South Coast Air Quality Management District

February 23, 2023

Mitigated Negative Declaration (MND) for the Proposed Cottonwood & Edgemont Project (Proposed Project) Master Plot Plan PEN21-0325, Plot Plan PEN21-0326

Figure A
Loading Docks and Truck Movements¹⁵

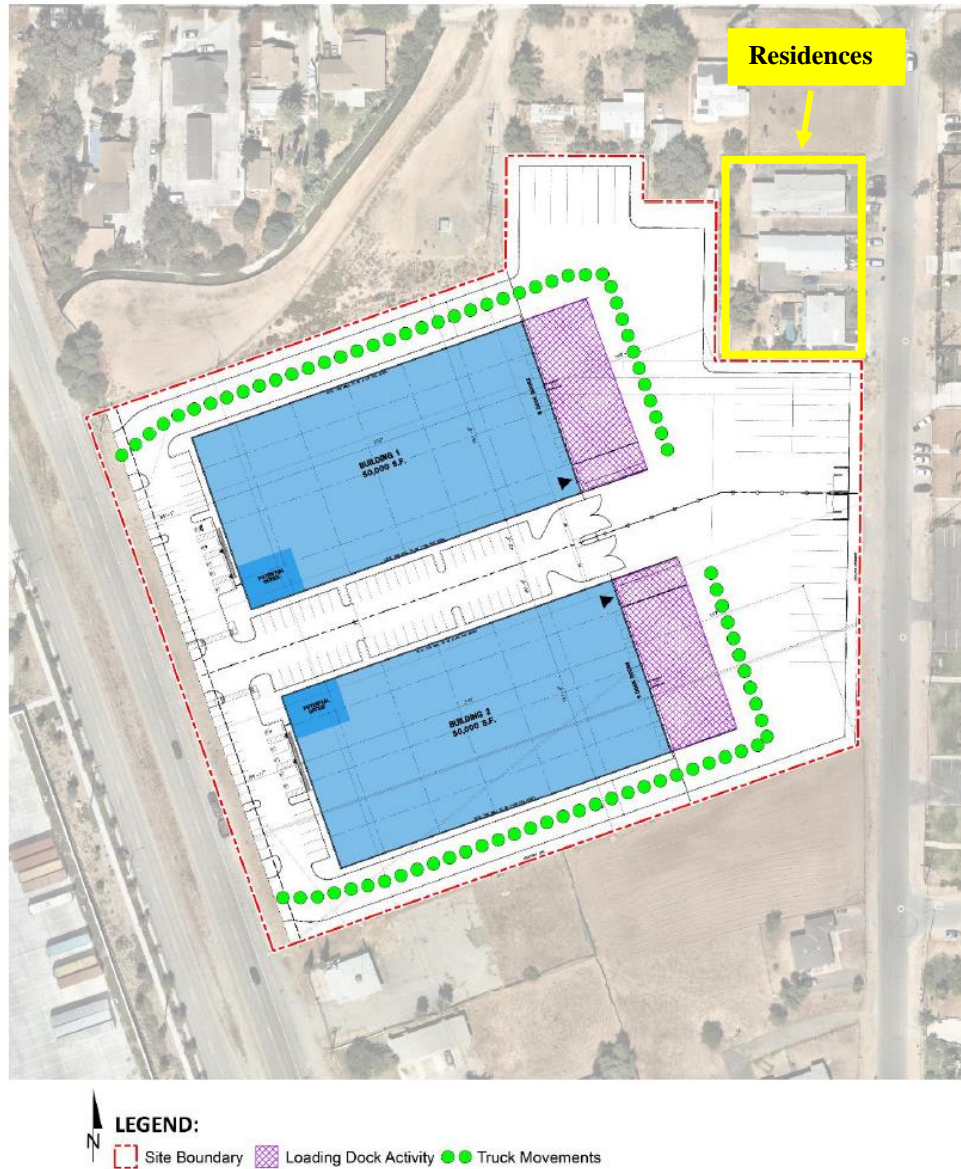
Based on the MND, the Proposed Project would have nine (9) dock doors located on the east side of each building.¹⁴ Based on the aerial photograph and Figure A below, South Coast AQMD staff is concerned about the loading dock orientation of the Proposed Project. These loading docks face Edgemont Street, where sensitive receptors (e.g., residences) are located, as noted in Figure A.

As a result, South Coast AQMD staff recommends that the Lead Agency re-consider the Proposed Project buildings’ design/orientation, such as placing loading docks further away from the sensitive receptors, to help reduce the impacts of the operational activities on the sensitive receptors. In the event that the Proposed Project’s design is revised, the Lead Agency should include the new design and its associated analysis (e.g., emissions calculations, HRA) in the Final MND.
